DATE: 10.17.2013
TO: ProTrak
FROM: Bill McDow
 Transportation Planning

■ **LOCKWOOD VILLAGE APARTMENTS [Initial plan review]**

↻ Initial Review Note ↻

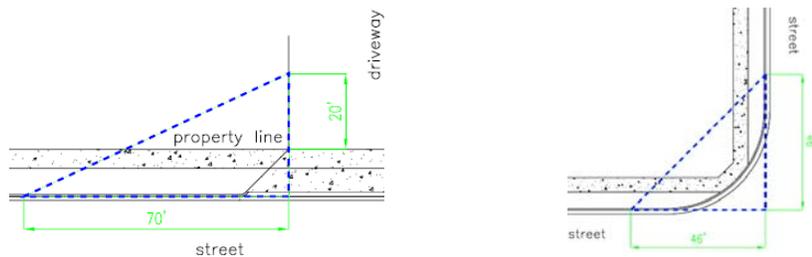
1. Revise the proposed right turn lane and deceleration lane for the site per NCDOT and City of Wilmington standards. Construct the lane as a full width turn lane beginning at Prior Drive and ending at the proposed private drive/street entrance for the site, in order to ensure a minimum of 100’ storage, 50’ of full width deceleration and 75’ of taper length is provided.
2. Any multi-family development of more than 50 units must be served by a public street.
